Re: Former Chevron Service Station No. 9-1026
3701 Broadway
Oakland, CA

Re: Work Plan Addendum
Former Chevron Station #9-1026
3701 Broadway
Oakland, California
Fuel Leak Case No. RO0500

Subject: Request for Work Plan Addendum; Fuel Leak Case No. RO0000500 (Global ID # T0600100334), Chevron #9-1026, 3701 Broadway, Oakland CA 94611

Figure 5
GEOLOGIC CROSS SECTION A-A' POST-EXCAVATION 2008
FORMER CHEVRON STATION 9-1026
3701 BROADWAY
Oakland, California

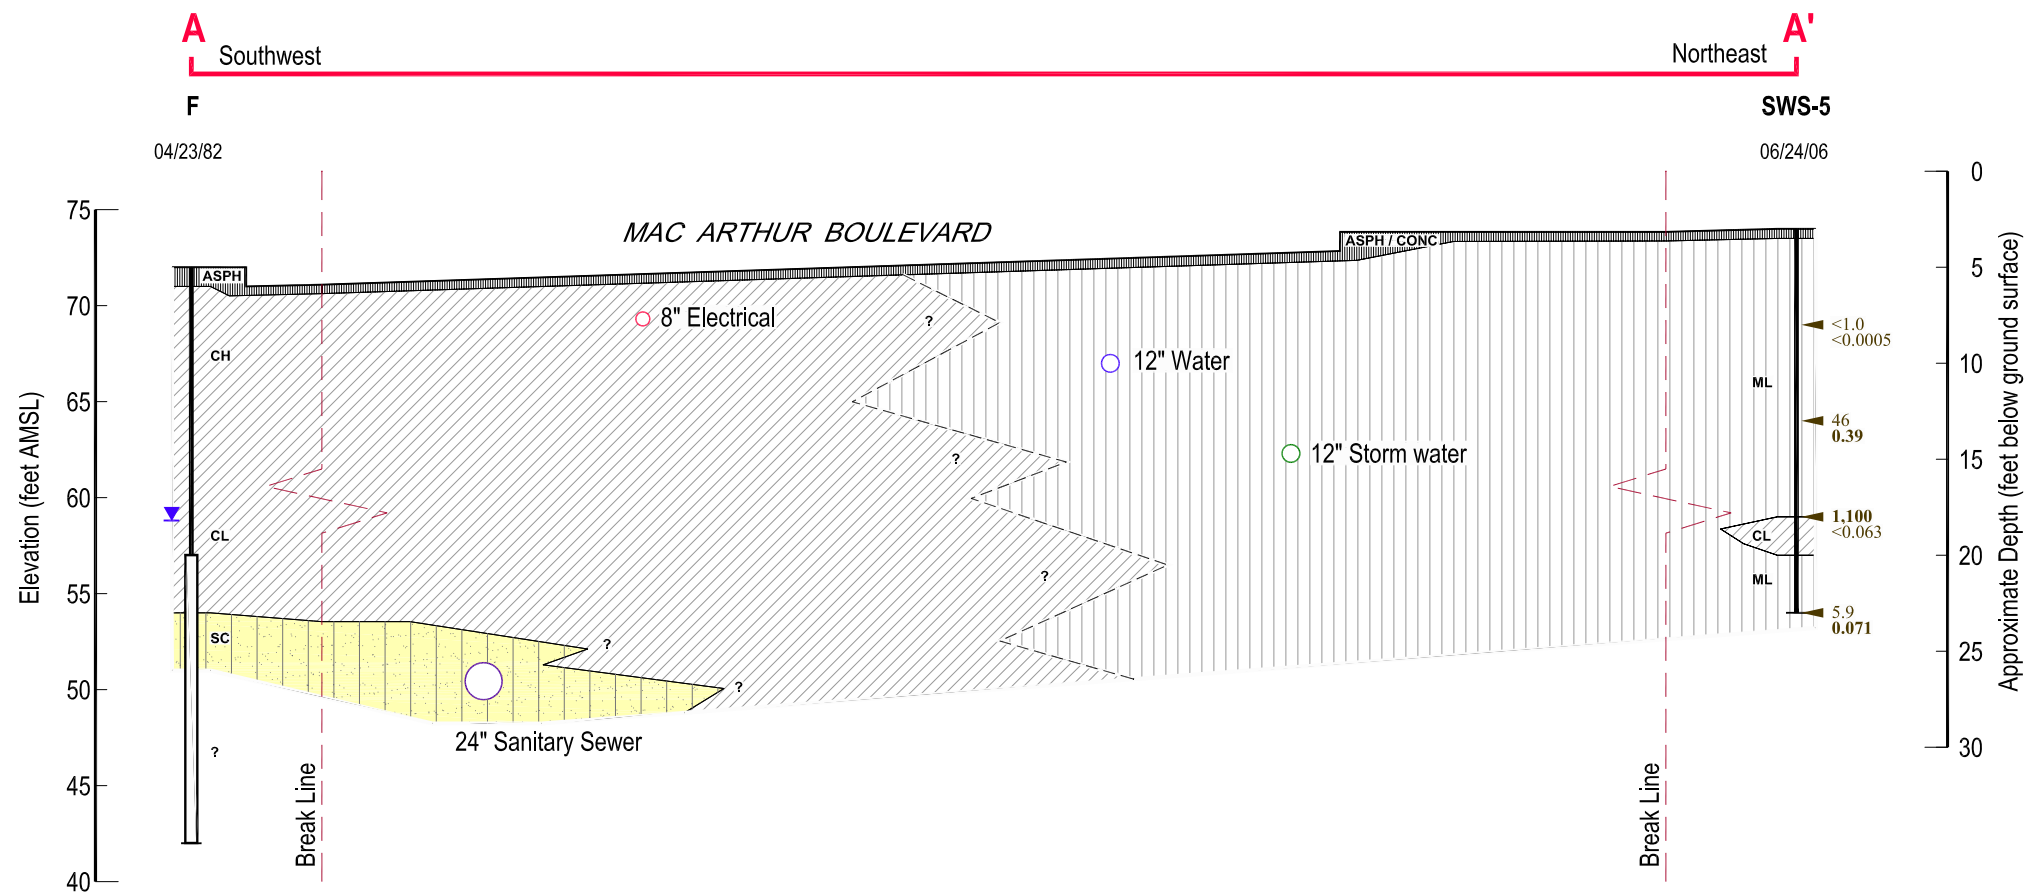
- b. Pre-excavation soil bores generally suggest two potential water bearing zones can be present in the upper 20 to 21 feet bgs at the site, one at approximately 8 to 12 feet bgs, and another varying between approximately 16 to 21 feet bgs (Please note correlations

are somewhat tentative; no site cross-sections have been located for the project). The interval at approximately 8 to 12 feet bgs contains indications of intermittent flow; due perhaps to rain or other temporary infiltration along an overbank splay originating from the westward deflection of Western Creek, now a channelized storm drain, at the northwest corner of the former Chevron parcel. In general, ACEH recommends the use of monitoring wells designed with sand pack intervals of 5 feet or less; as these wells will likely be representative of depth discrete groundwater conditions. Because the area of backfill will largely act as a basin intercepting groundwater flow from these two depth intervals, it may be appropriate to link the two zones for the proposed wells closest to the Macarthur sidewalk (i.e. to monitor the overexcavation backfill basin as a single unit). For the well closest to the former UST basin, it appears the well will be installed in native soils; consequently a more appropriate short well screening interval should be identified prior to well installation. ACEH requests the generation of a minimum of two cross sections, one parallel and one perpendicular to the predominate direction of groundwater flow, prior to well installation using pre- and post-excavation elevations. Please include these cross sections, or any additional sections deemed appropriate in the Work Plan Addendum requested below. Please include utility corridors or other known preferential pathway in the cross sections (see below).

- b. Cross-sections illustrating site lithology, well screens, and underground utilities beneath MacArthur Boulevard are included as Figures 3 through 8. A review of site boring log data reveals one water-bearing zone of silty and clayey sands beneath the clay at depths of approximately 18 to 20 fbg (Figures 3 through 8). After the confined water-bearing zone is penetrated, static groundwater in the wells rises to approximately 12 fbg.

Figure 6
GEOLOGIC CROSS SECTION A-A' - CUTAWAY STREET DETAIL
FORMER CHEVRON STATION 9-1026
3701 BROADWAY
Oakland, California

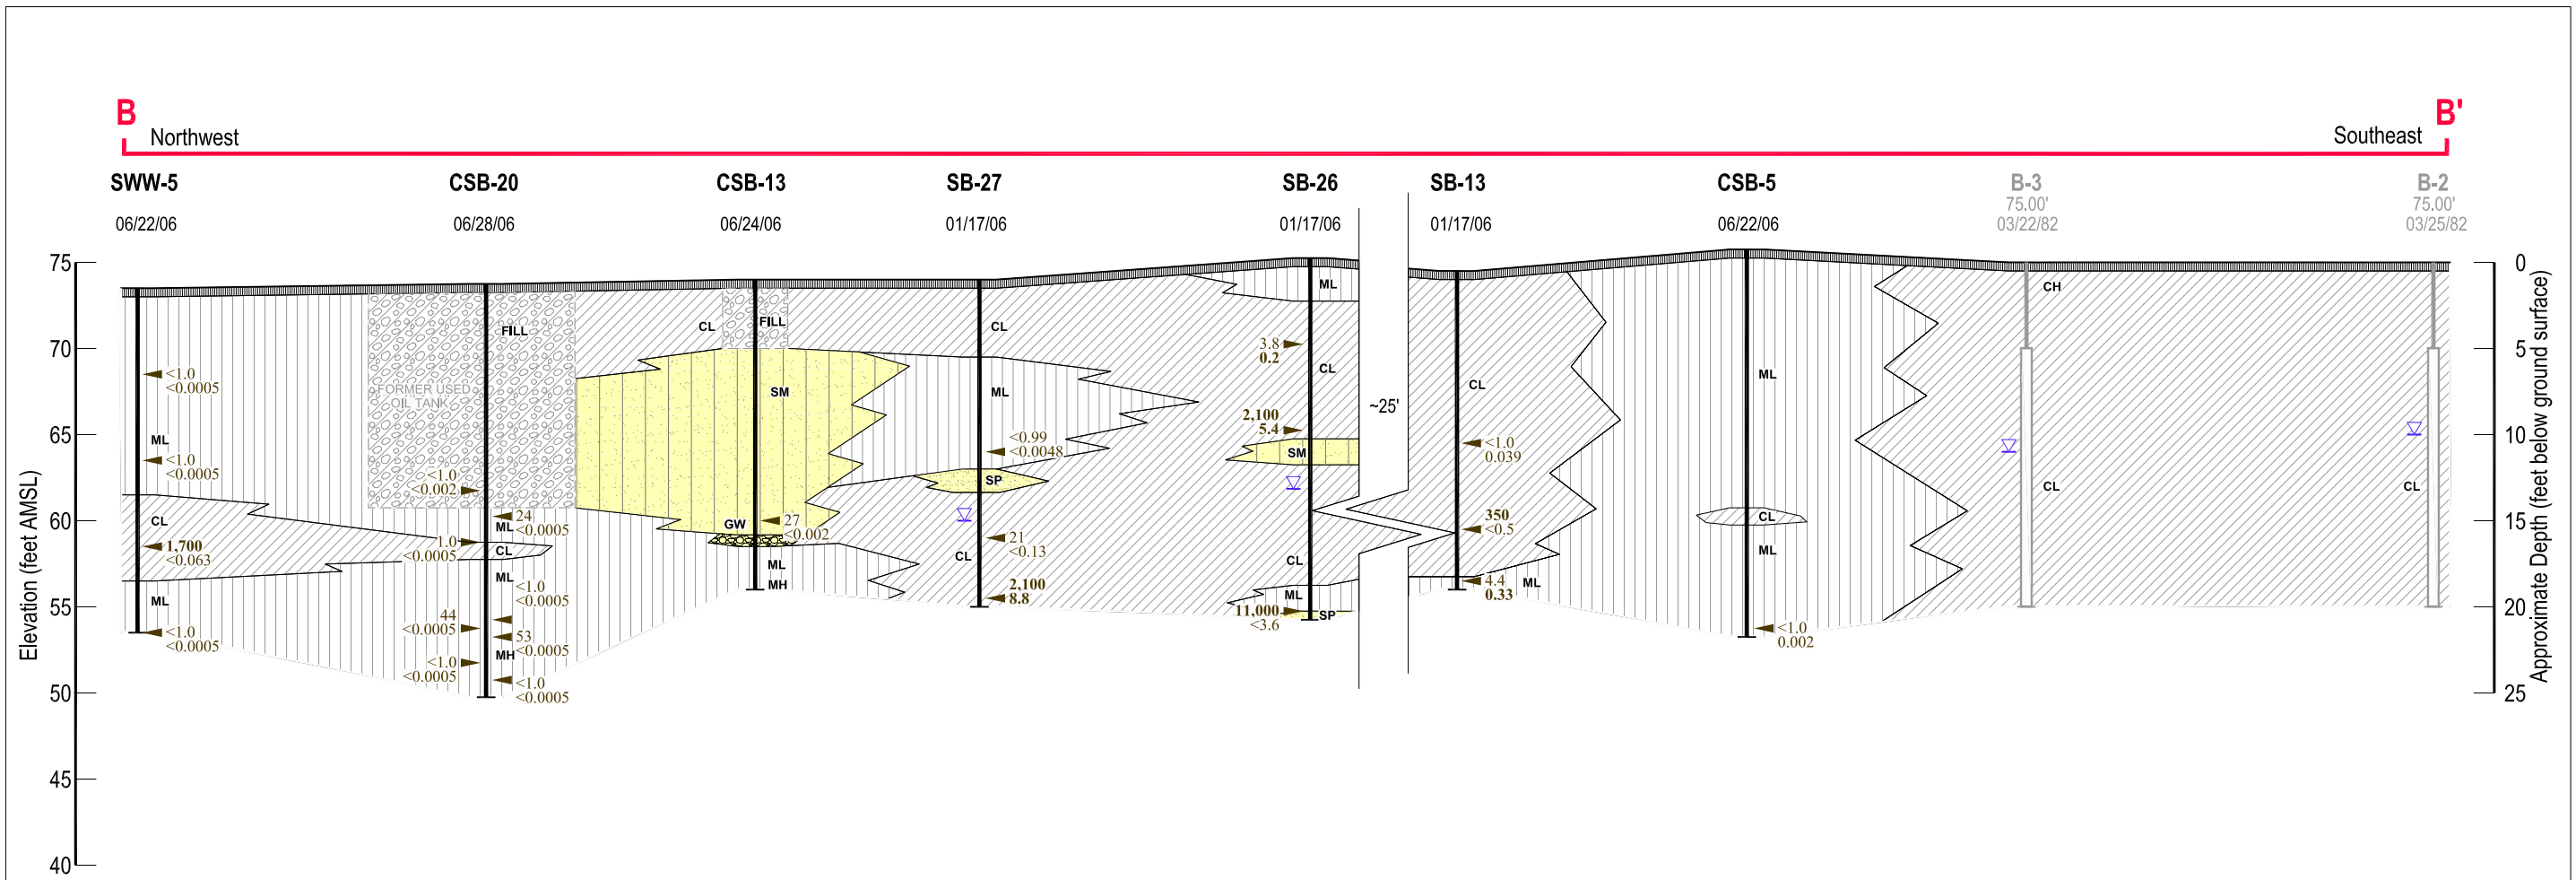
2. **Preferential Pathway Analysis** – Please further investigate preferential pathways including the depth of burial of utility corridors. Per Figure 2 of the SECOR *Soil Management Implementation* Report, dated June 11, 2008, a sanitary sewer manhole at the intersection of Broadway and Macarthur Boulevard has a rim elevation of 75.05 feet, while the invert has an elevation of 51.7 feet. While perhaps atypical, the 23.35 foot depth does not conform to the 1.5 to 8 foot typical burial cited in the Work Plan. ACEH remains concerned preferential pathways may exist in the site vicinity. Please depict utility corridors in the previously requested cross-sections.

As requested, CRA obtained city sanitary sewer and storm drain maps. The locations and depths of the sanitary sewer, storm drain, water, and electrical lines beneath MacArthur Boulevard are illustrated on Figure 7. A preferential pathway analysis will be conducted and submitted with the *Well Installation Report*.
